Botley West Solar Farm

PINS Ref: EN010147

Document Ref: EN010147/APP/21.7

MASTERPLAN DEVELOPMENT & RATIONALE | JULY 2026

Figure 1 - Reduction in Overall Development Area Animation

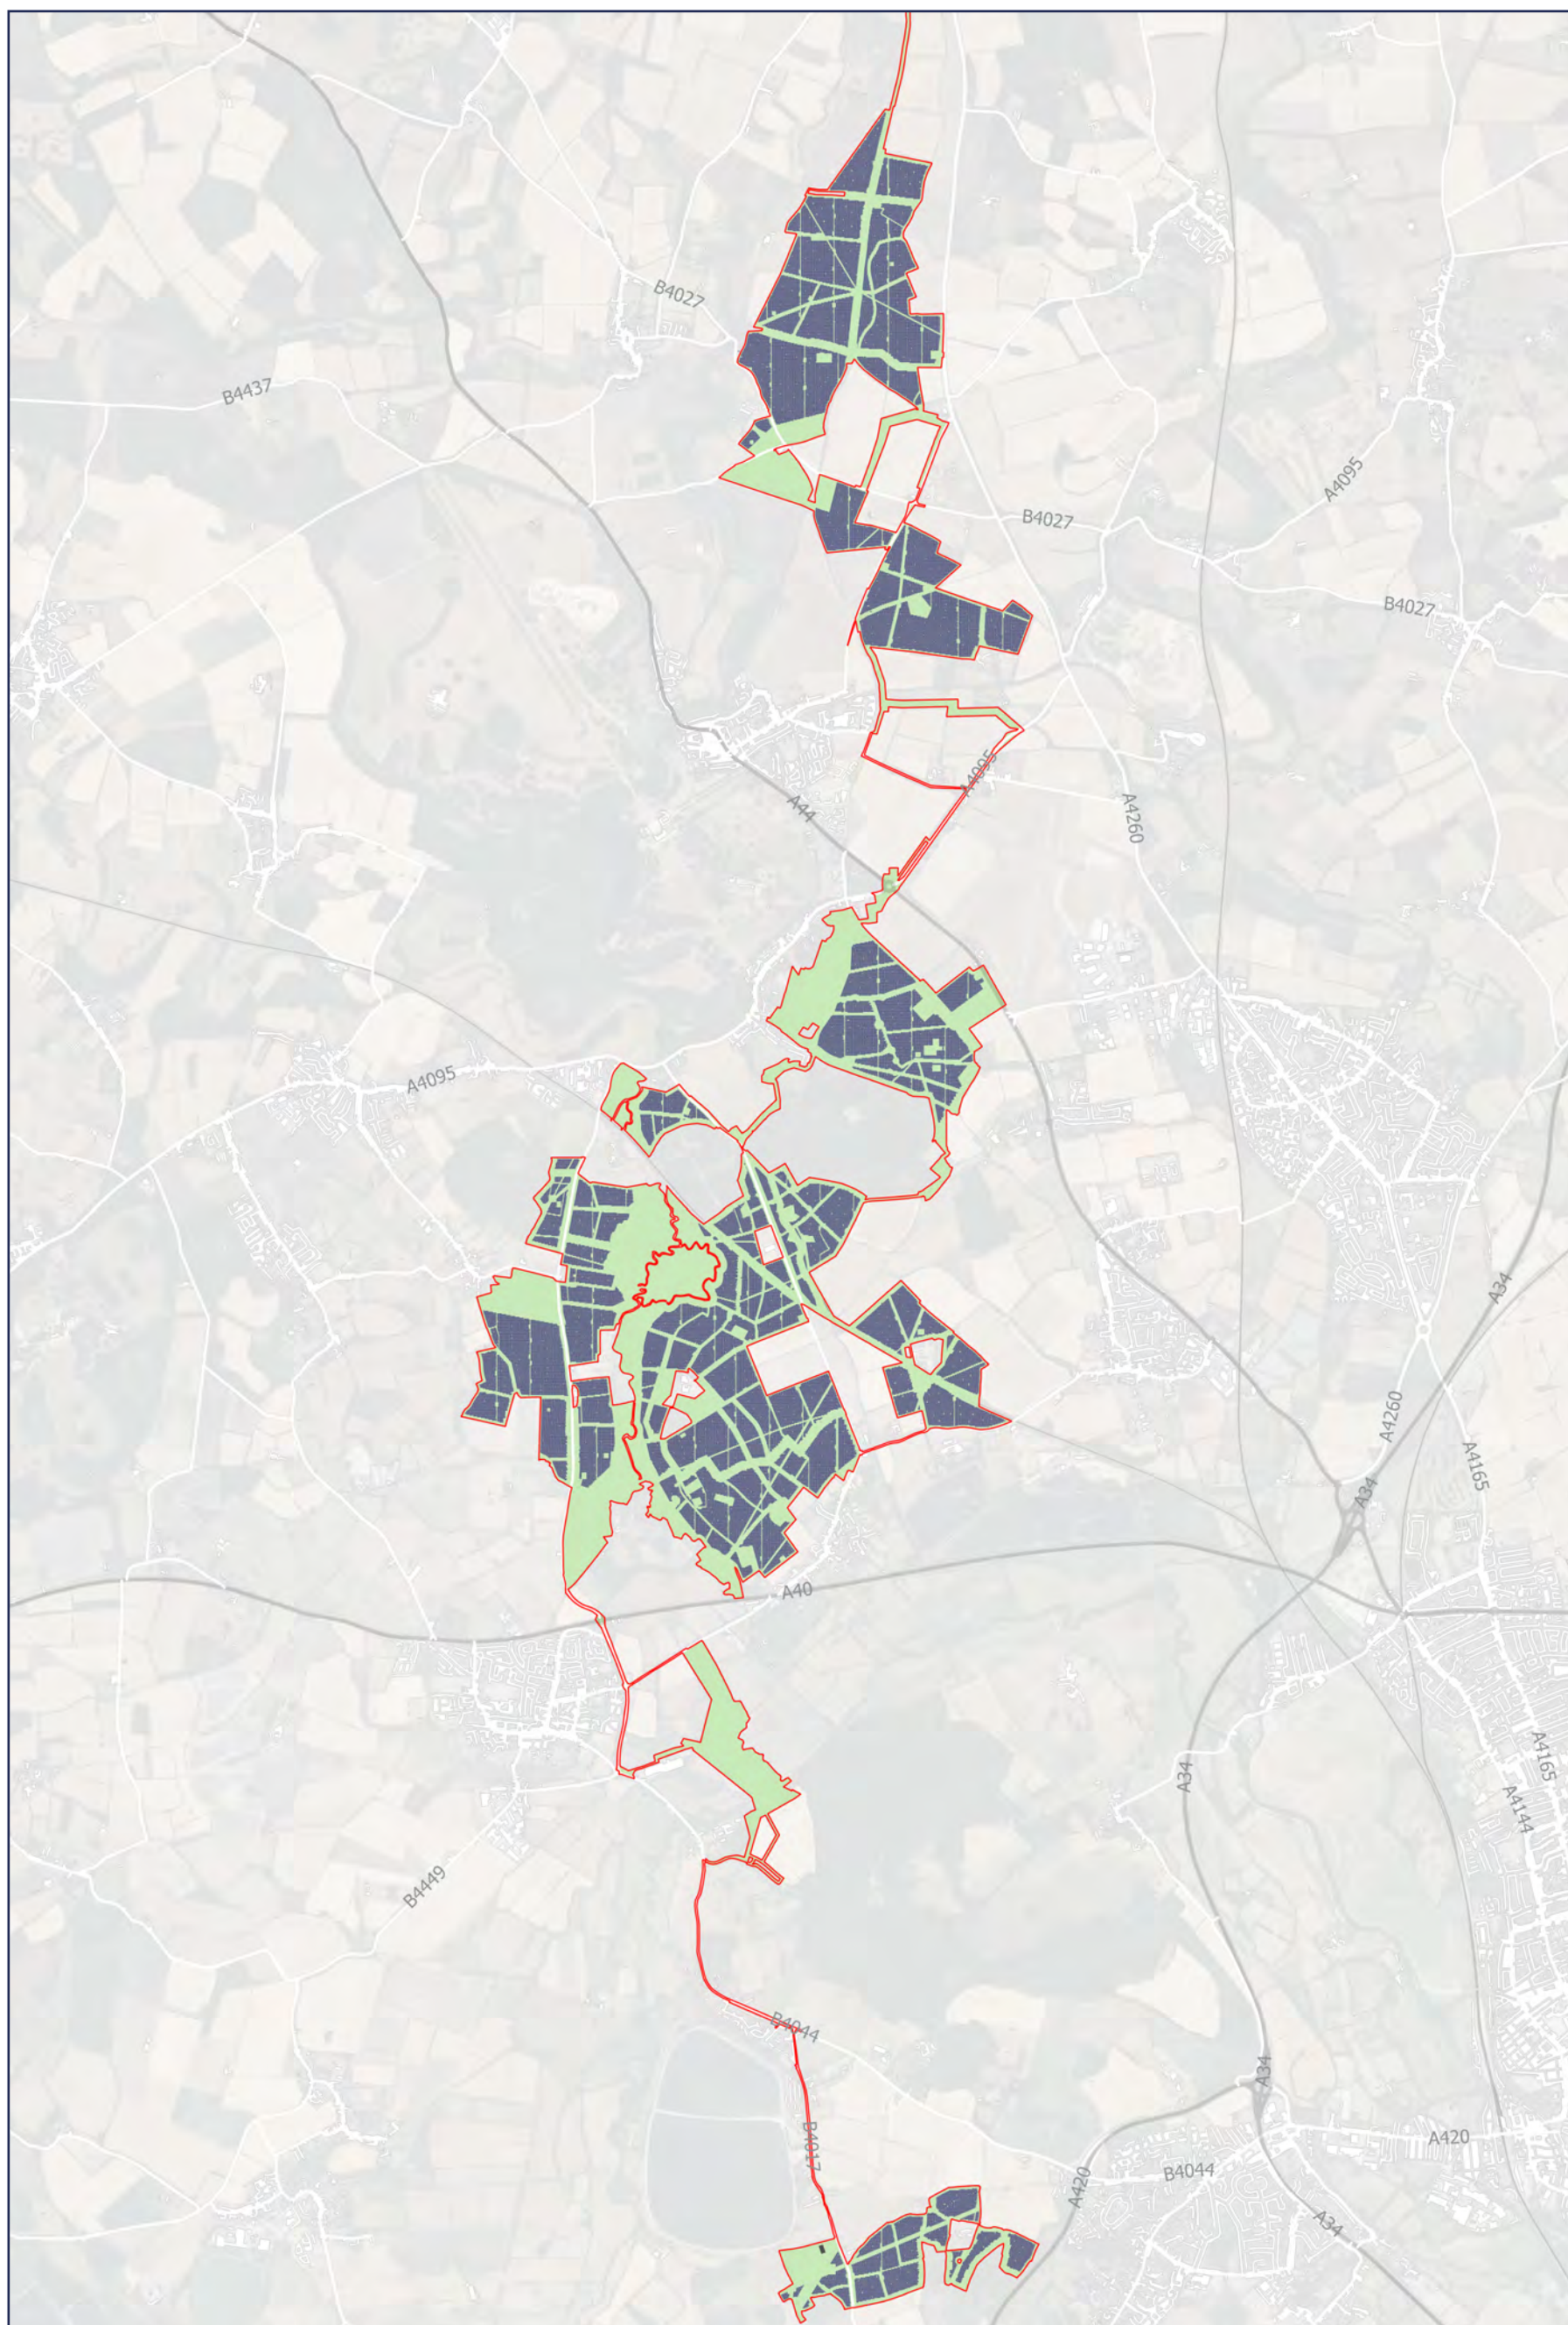
- 1.11
- Collectively, these changes have resulted in a substantial reduction in the extent of the operational development area compared with the original DCO submission, as visualised in figure 1 on the following page (please click on the buttons at the top of the page to switch between the original and proposed masterplans.

- 1.12
- In total, the solar panel installation area has been reduced by **130.23ha**, representing a reduction in generating capacity of approximately **219.8 MWp**.

Figure 2 - Northern Area Masterplan Changes Animation

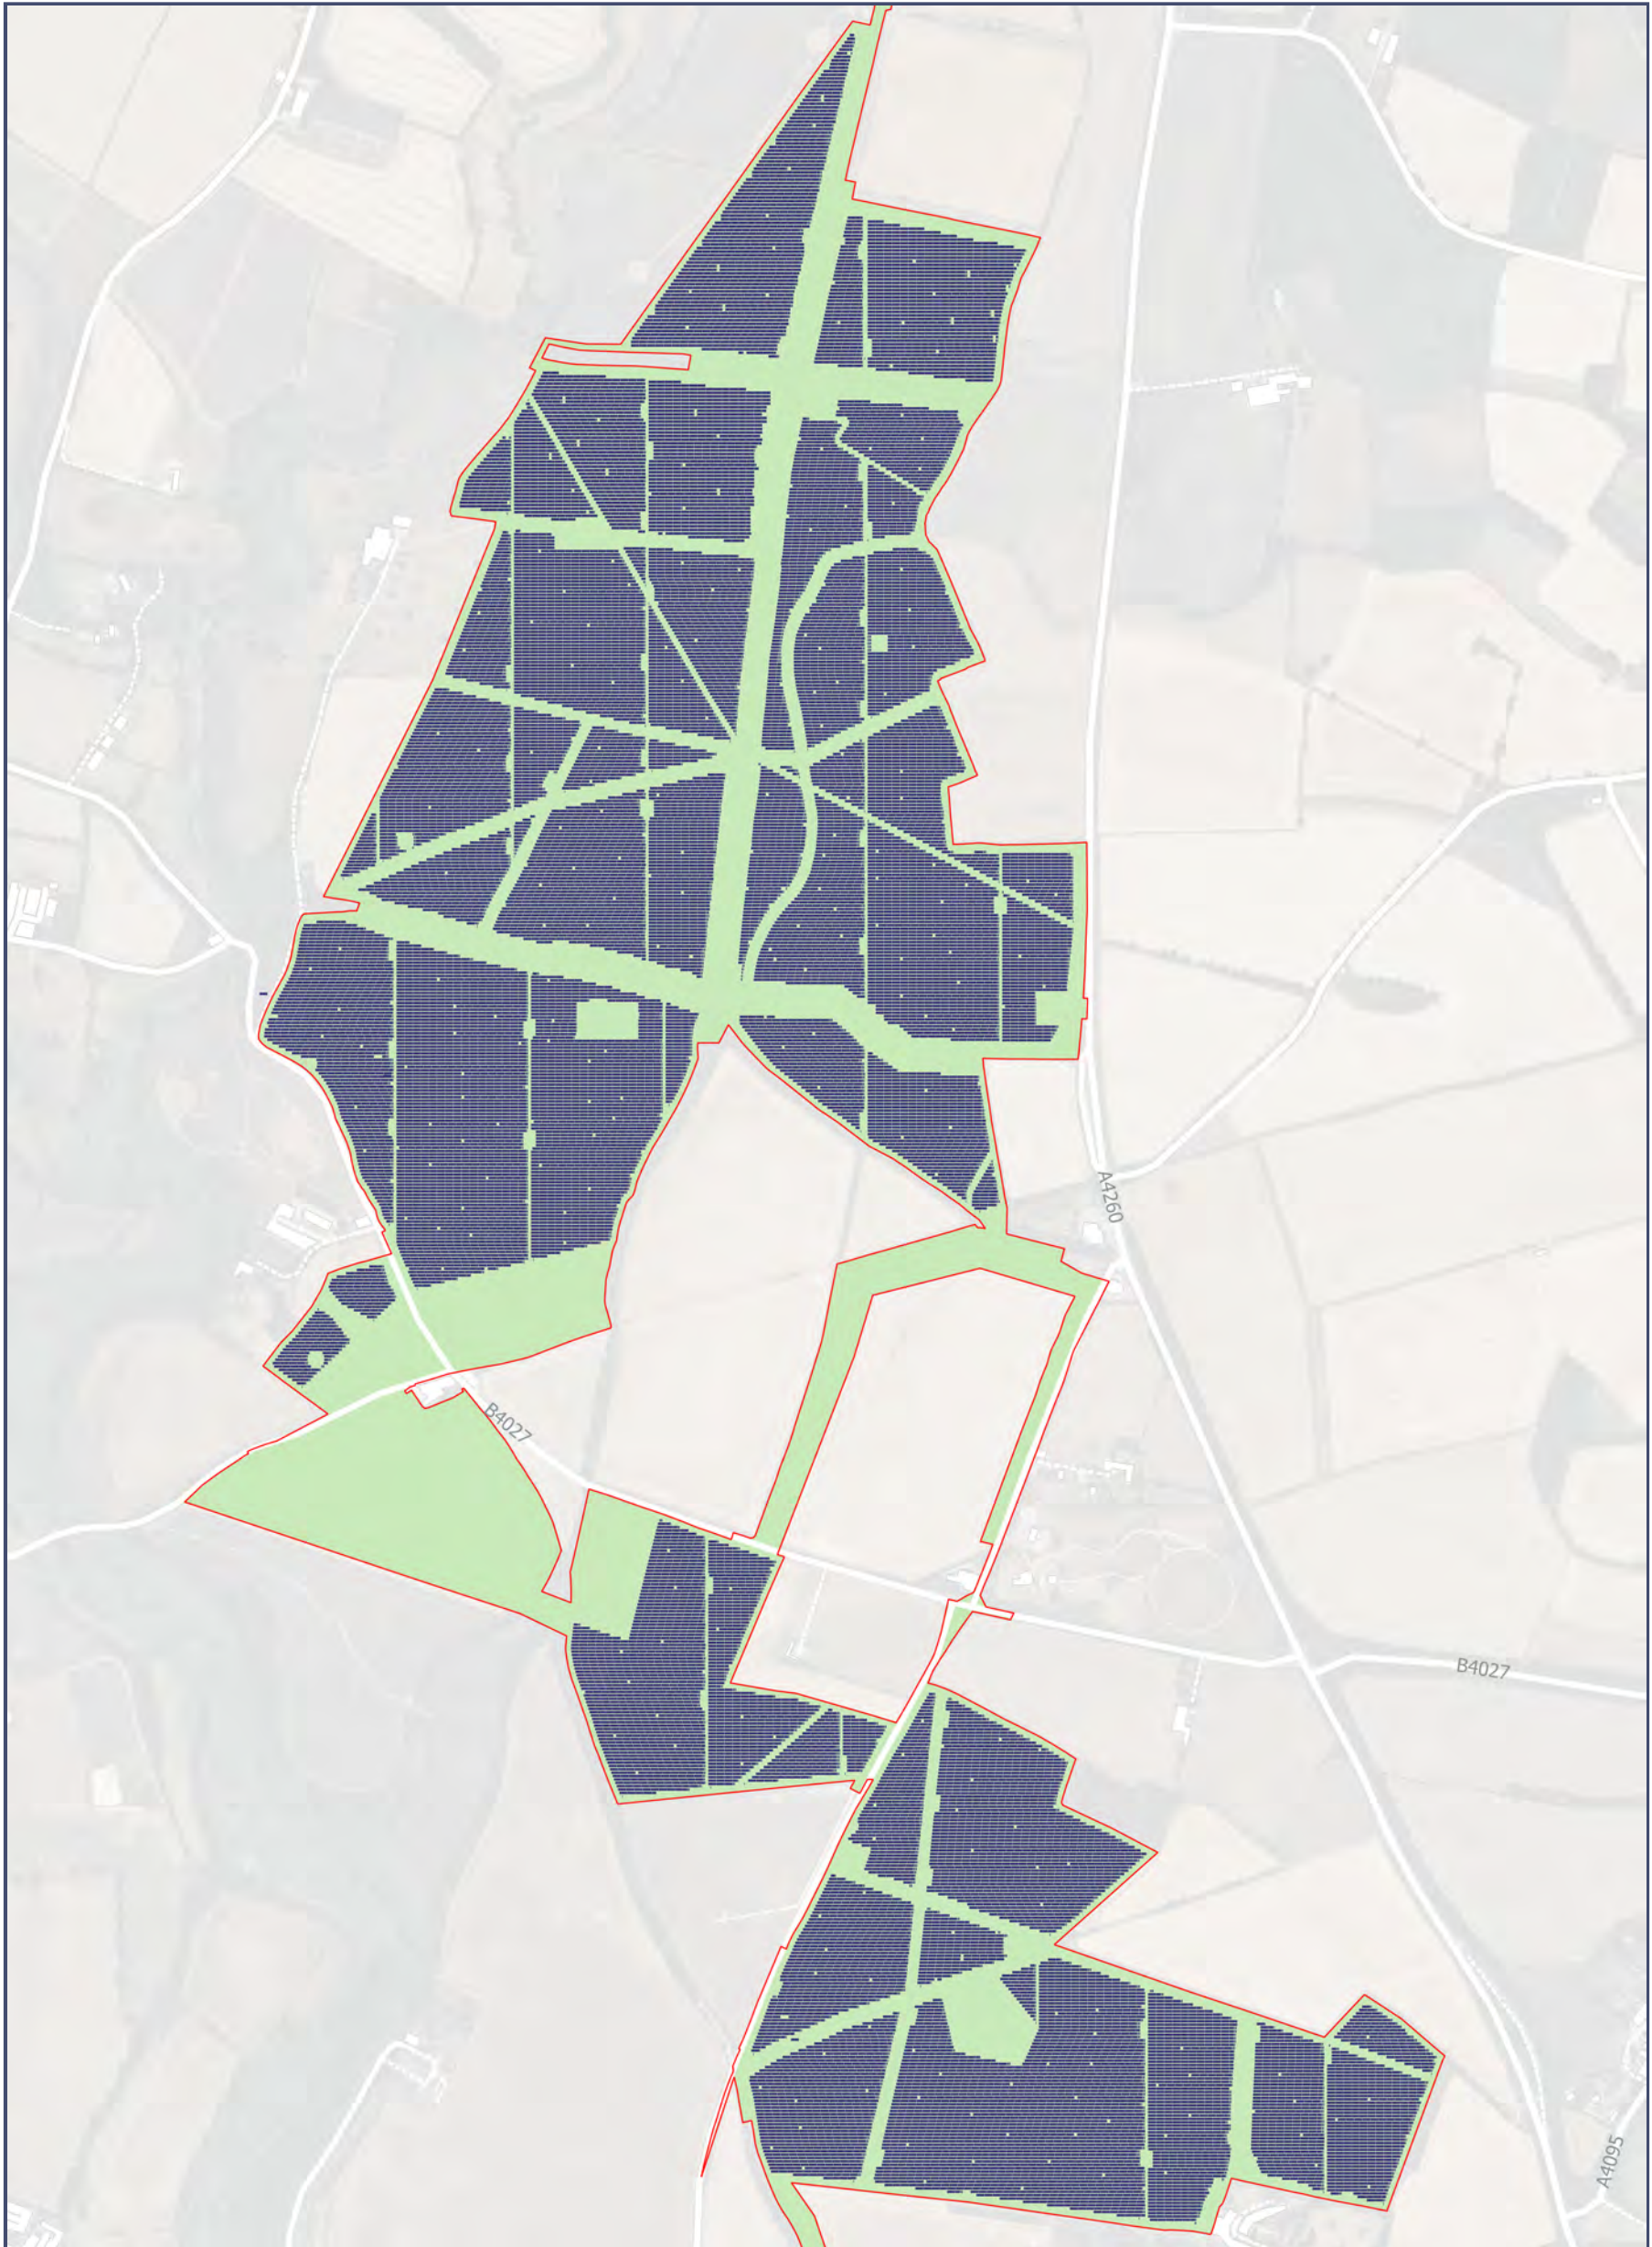
- 2.1 The northern area of the Proposed Development has undergone a series of targeted design refinements following the close of the Examination, in response to further landscape and visual assessment, additional site survey work and ongoing discussions with the OHA.

- 2.2 The amendments to the masterplan within the northern part of the site focus primarily on the relationship between the Proposed Development and nearby residential properties.

- 2.3 Rather than applying a uniform approach across the site, the revised masterplan responds to the specific characteristics, orientation and visual relationship of each receptor. This has resulted in the selective removal of solar panel arrays where they formed part of the immediate setting or principal outlook from residential properties.

Removal of Panels East of Dornford Cottage

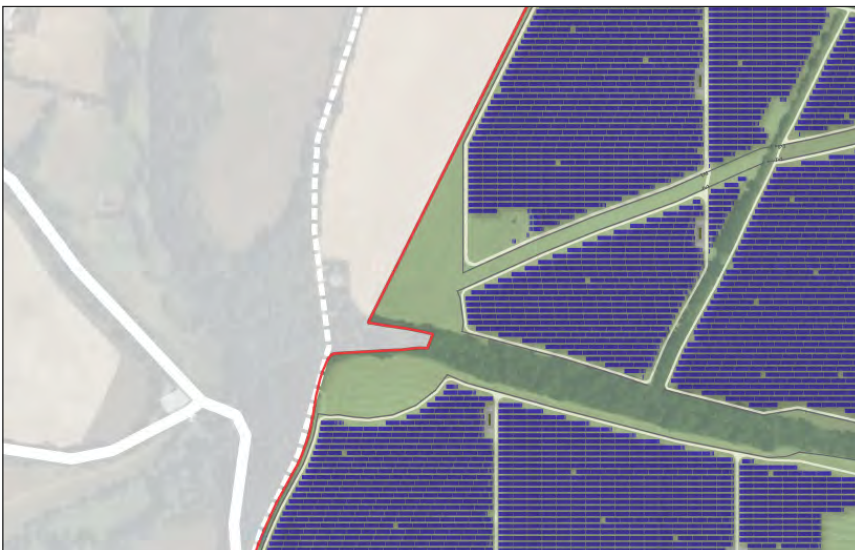
- 2.7 Solar panels have been removed immediately to the east of Dornford Cottage to retain the property's immediate open setting.
- 2.8 The original masterplan located development into the foreground of views from the dwelling. Although potentially mitigated through new planting, further design considerations concluded that the most appropriate response was to remove the development from this location.
- 2.9 This amendment increases the extent of undeveloped land immediately adjacent to the property, preserving the perception of openness that currently characterises the setting of Dornford Cottage. The retained land also provides additional opportunities for landscape enhancement and ecological management, reinforcing the rural transition between the dwelling and the wider solar development.
